CITY OF STAR

LAND USE STAFF REPORT

FILE(S) #: AZ-26064 Annexation and Zoning
DA-26-005 Development Agreement
PP-26066 Preliminary Plat for Jasper Ridge Subdivision

SITE DEVELOPMENT FEATURES

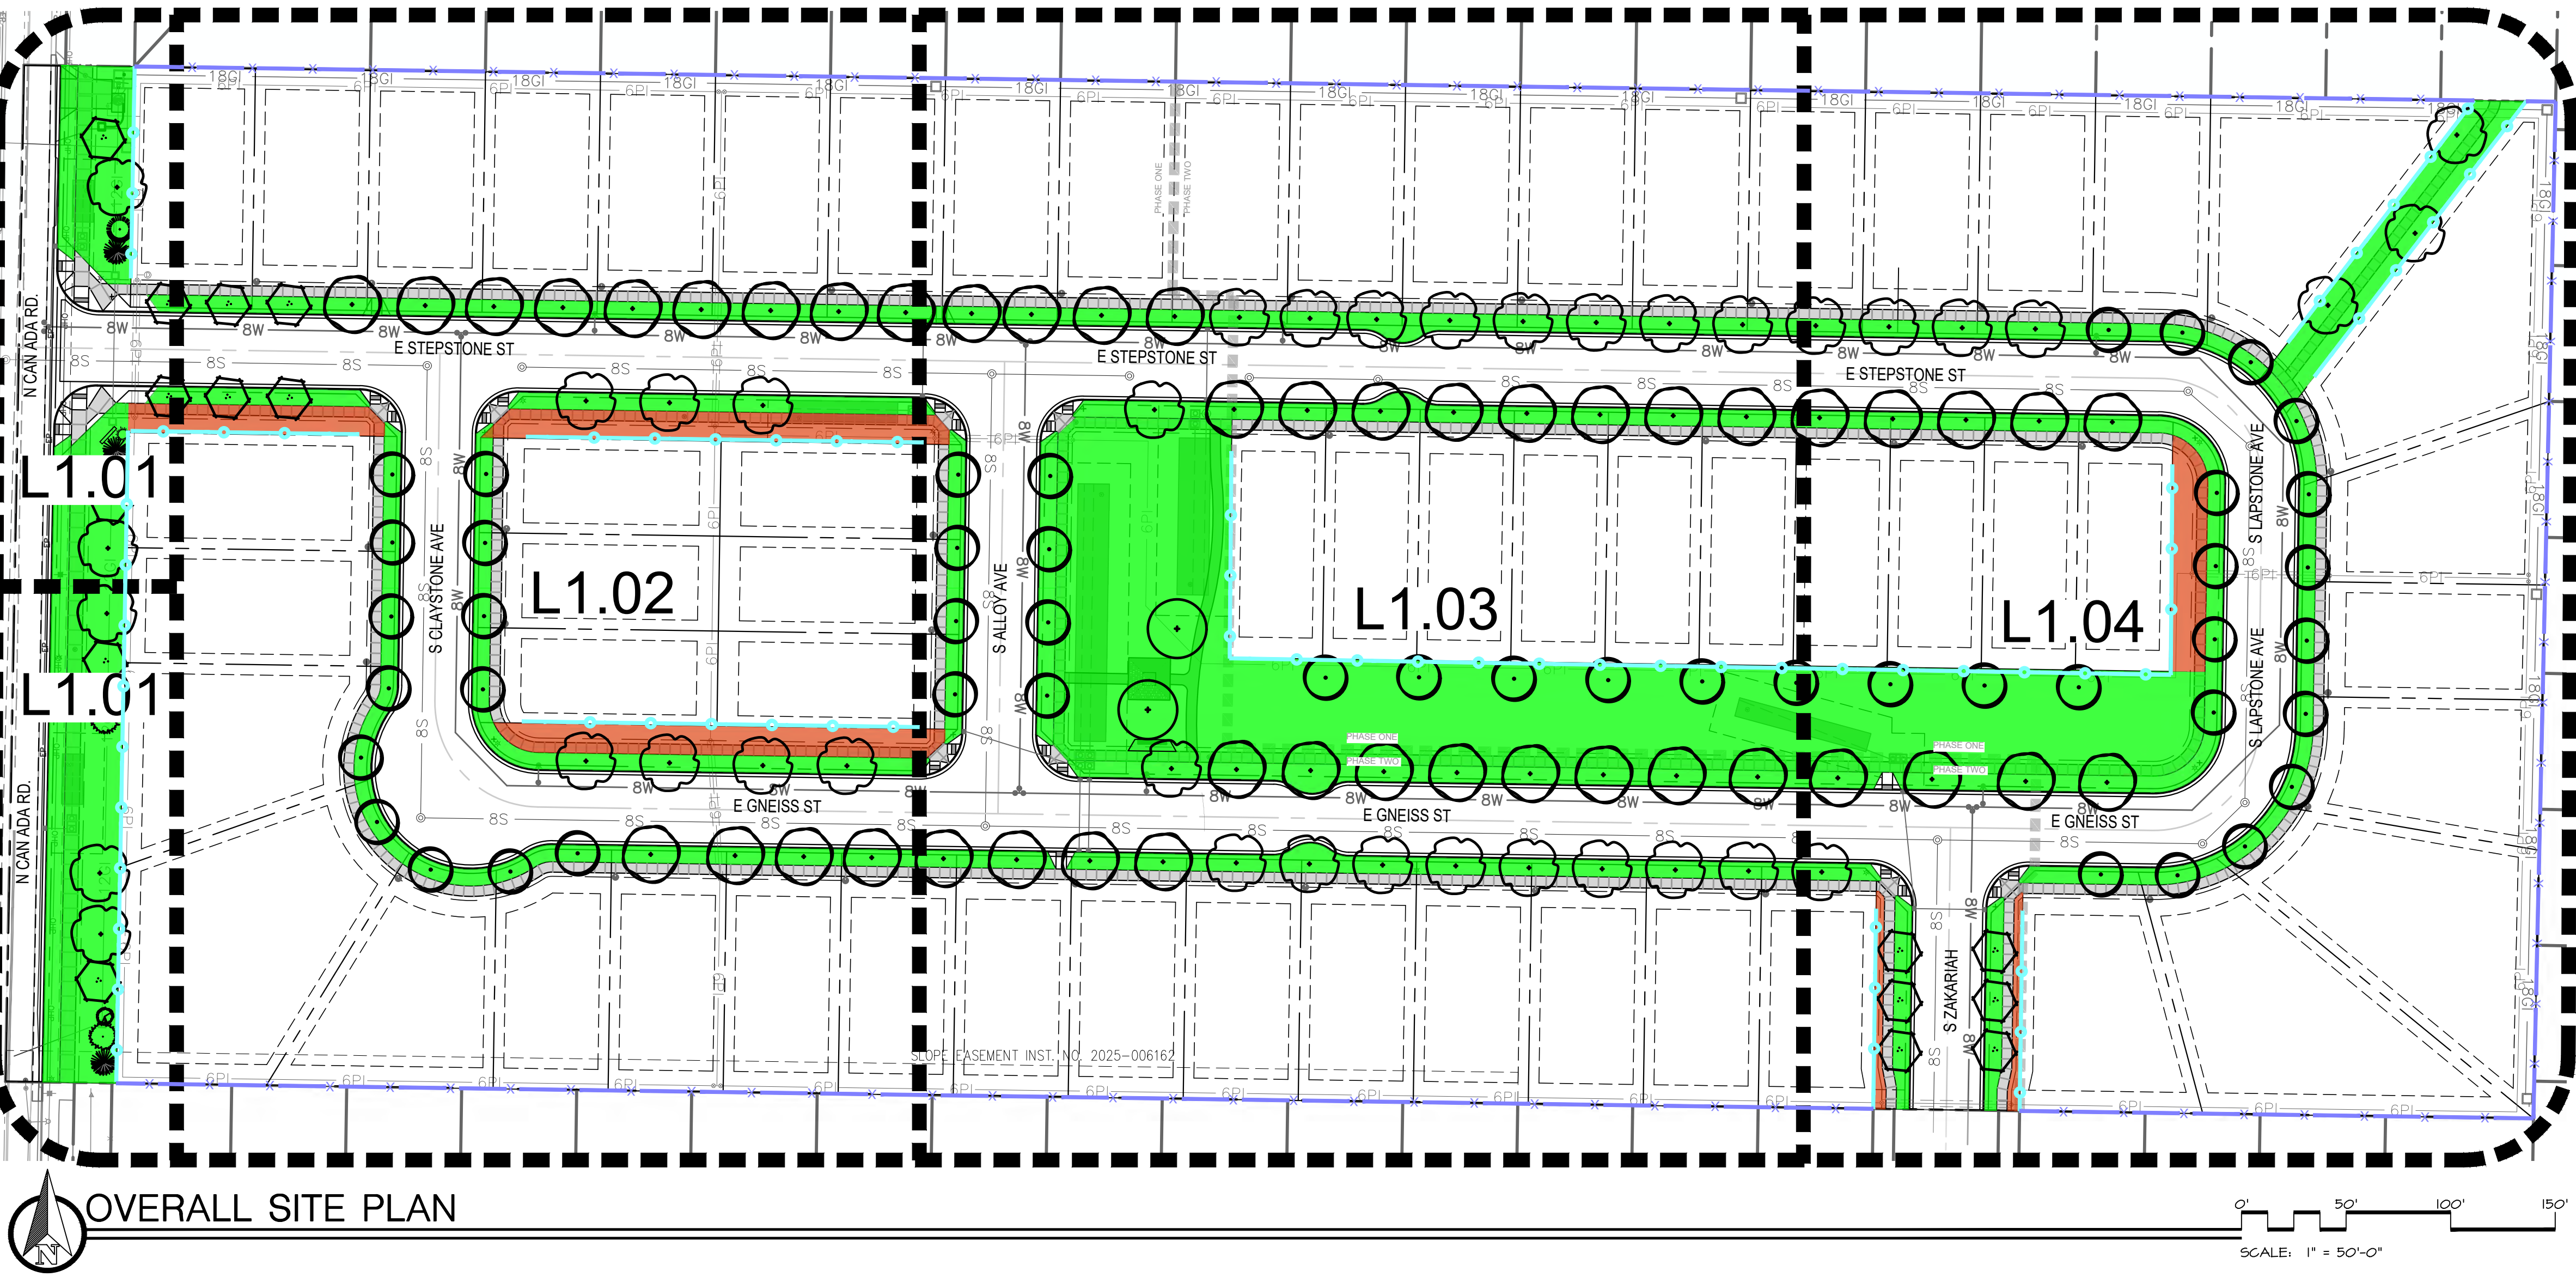
Sidewalk design submitted for the internal, local streets meet the requirements of the UDC. For the Can Ada Road sidewalk, the approved City of Star Pathway Master Plan requires this sidewalk to be a minimum of 8', as it is designated as a Community Pathway. **The applicant shall revise the Preliminary Plat to include this required width.**

3. **The applicant shall pay all required emergency services mitigation fees to the City, as determined by City Council.**
4. **Applicant shall submit a revised preliminary plat showing a minimum 8' sidewalk along Can Ada Road.**
